J2025-0107
PSP2025-0006
Revision #2

PINE TRACE GOLF
COURSE

SITE PLAN - REV.pdf Markup Summary

FLOOR PLAN -
BANQUET

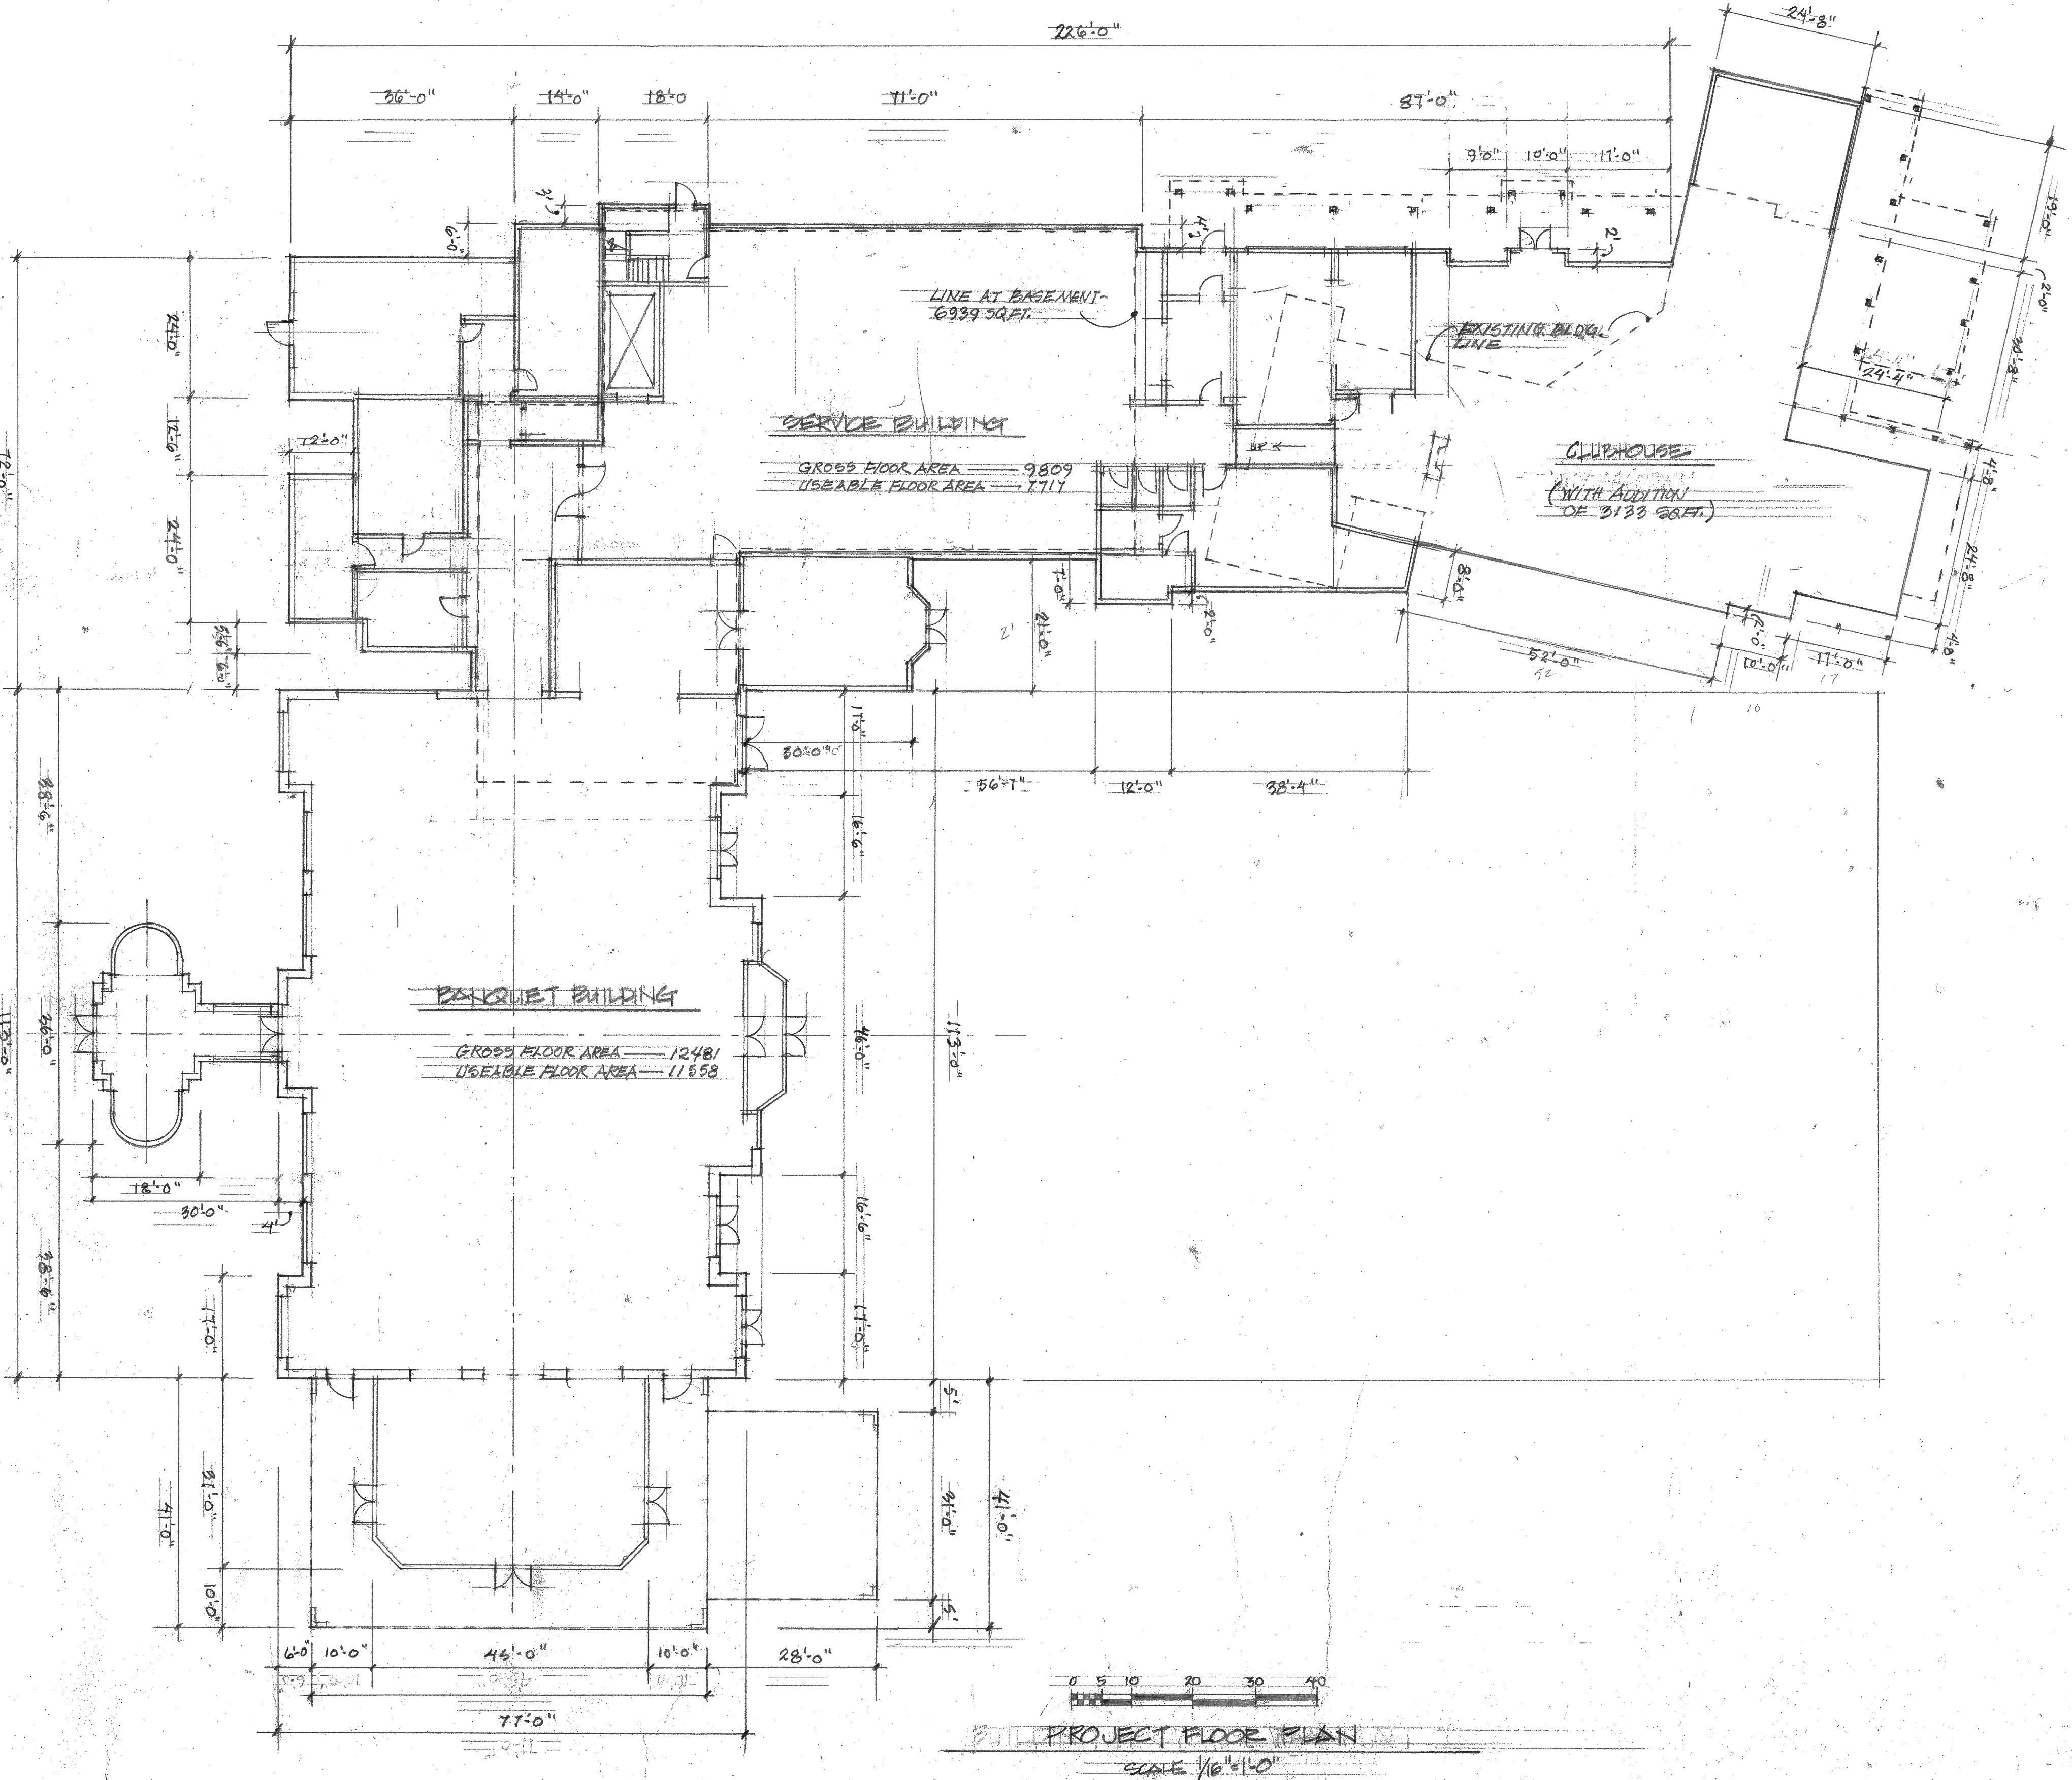
During the site plan review of the proposed building addition it has been determined that it does not comply with Table 506.2 of the 2021 Michigan Building Code for allowable area. Applicant has acknowledged they will address these requirements during building permit review with the following comment. "we are requesting the site plan package be approved contingent upon satisfying these comments during building permit review."

It will be the responsibility of the design professional to demonstrate compliance during the building permit application process. Building approves the site plan with the condition that this issue will be resolved during the building permit review process.

FLOOR PLAN & ELEVATIONS - DRIVING RANGE

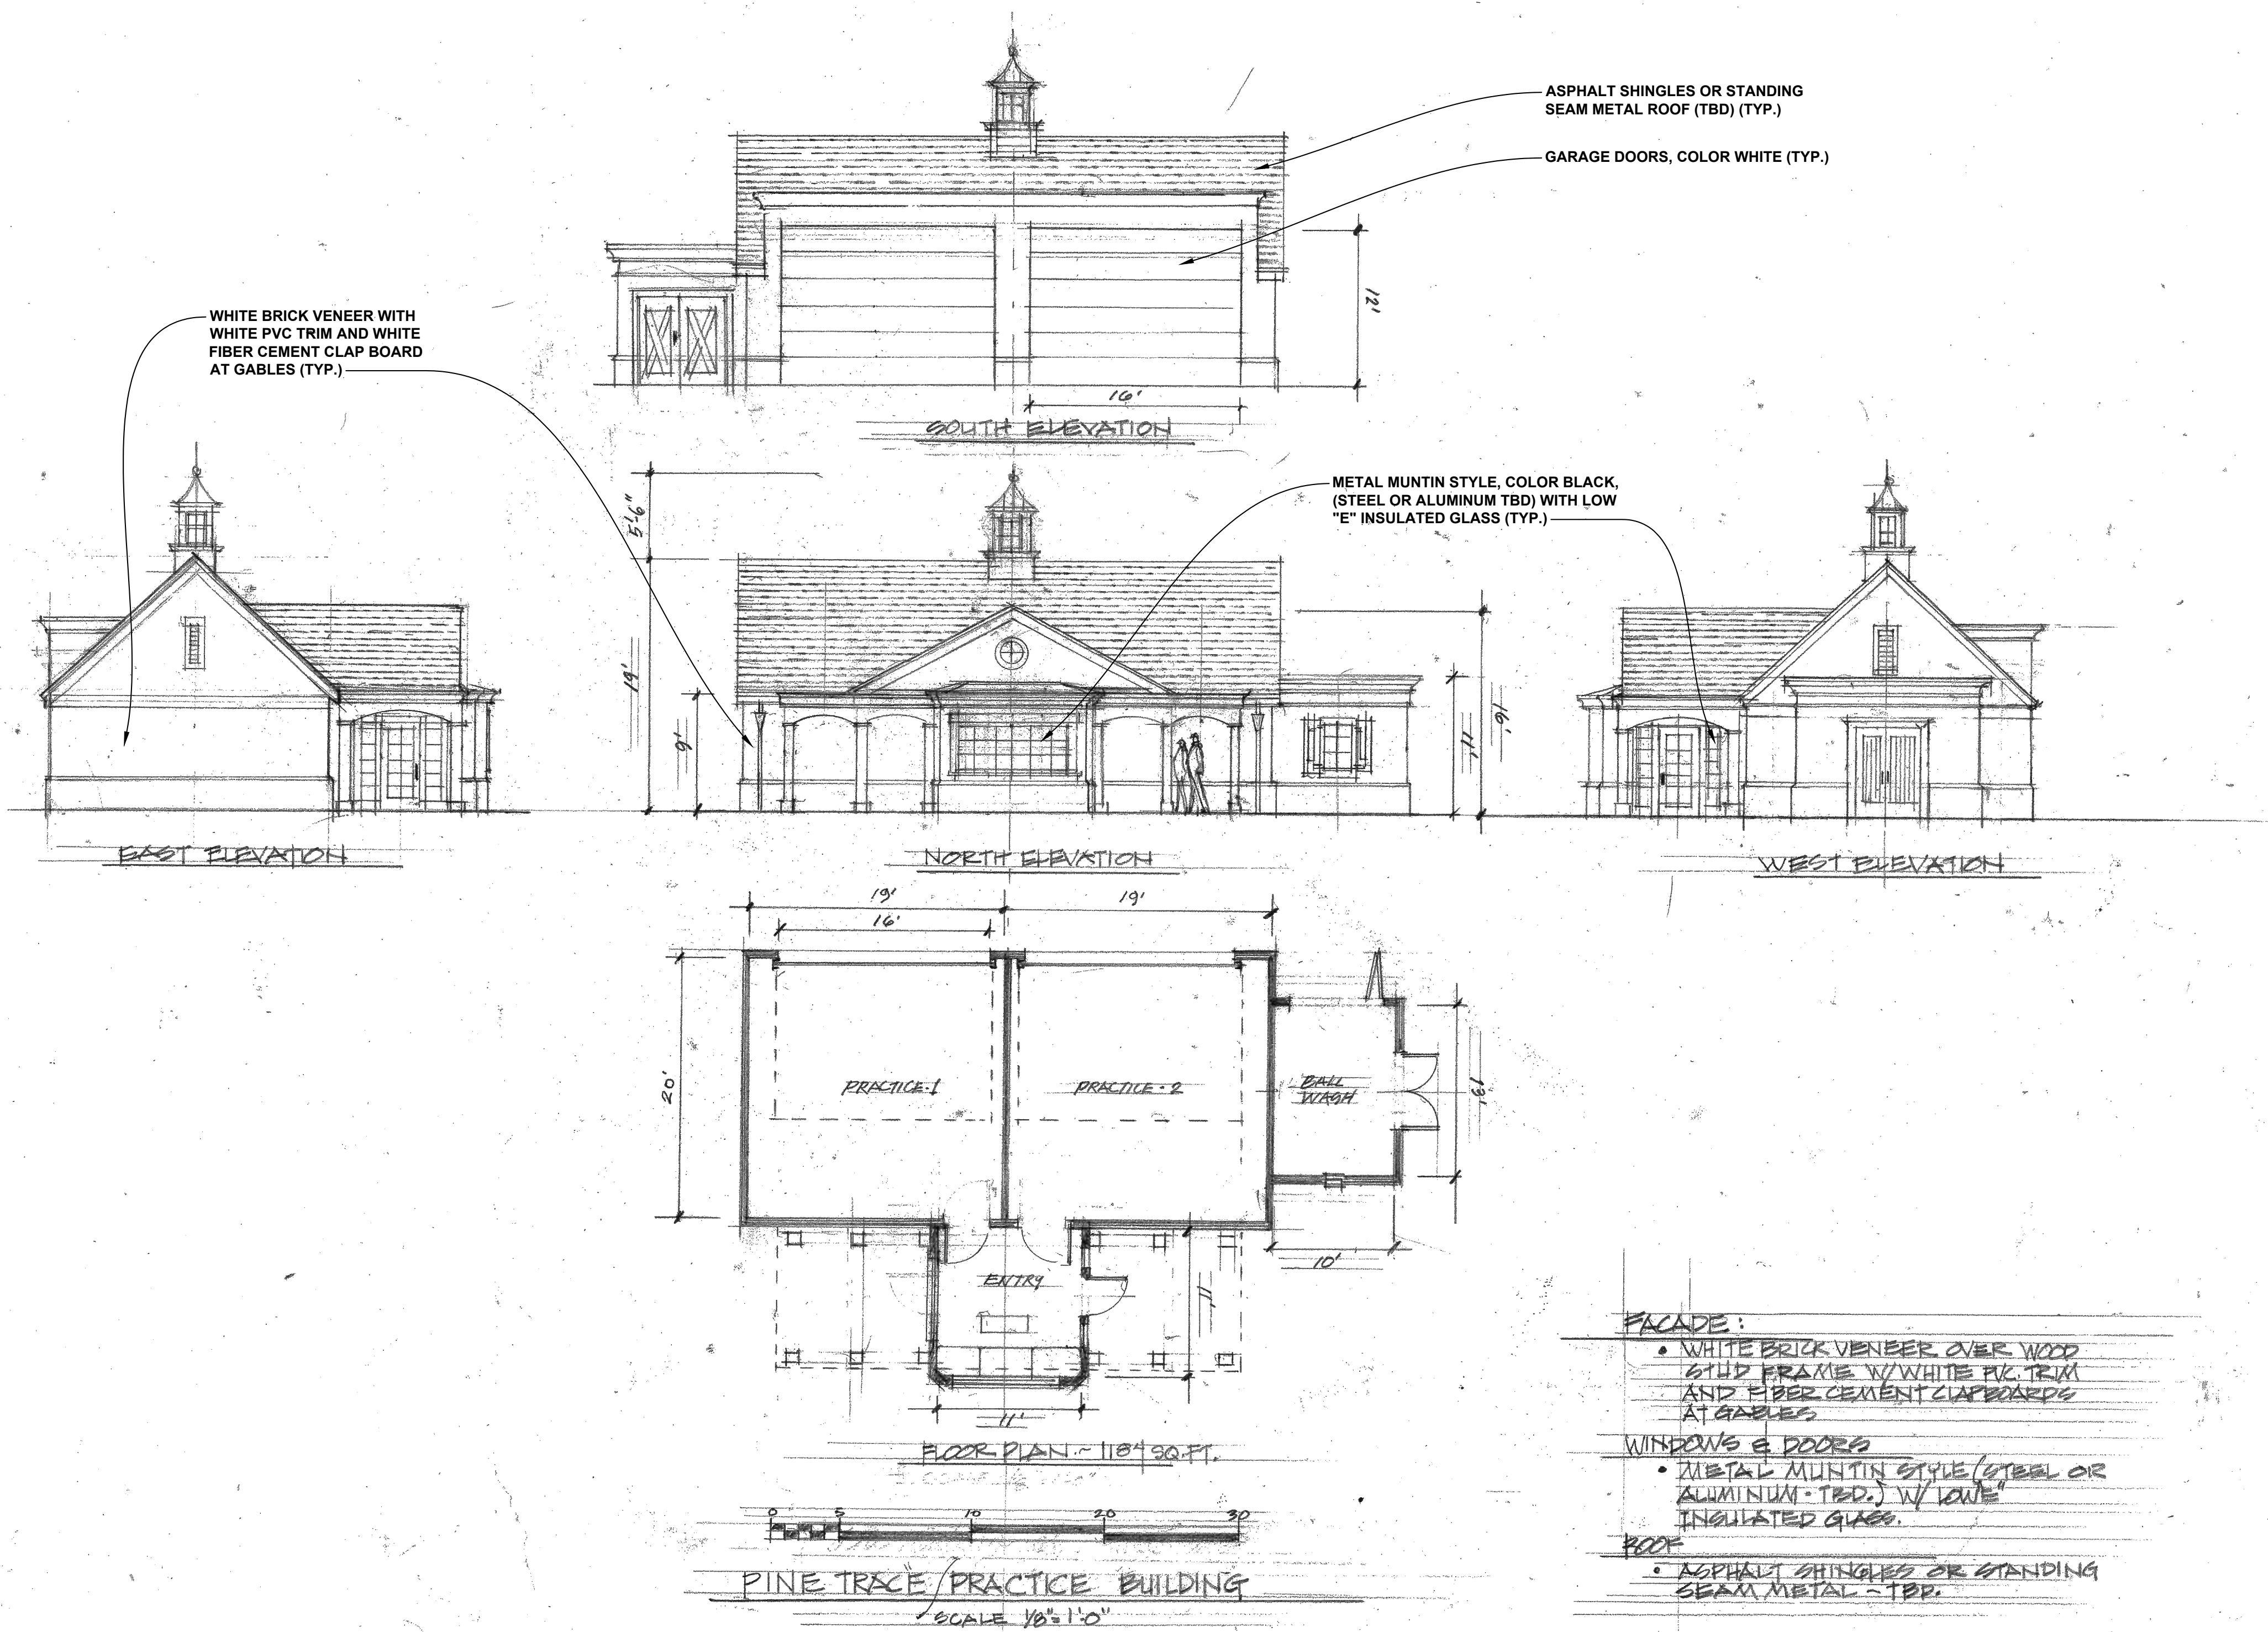
|  | Subject: Planning Department Author: C.McLeod Date: 6/23/2025 9:32:46 AM Status: | These improvements should be incorporated into existing site plan/construction plans for previously approved driving range. No action necessary on this set of plans. Just noted for informational purposes. | |
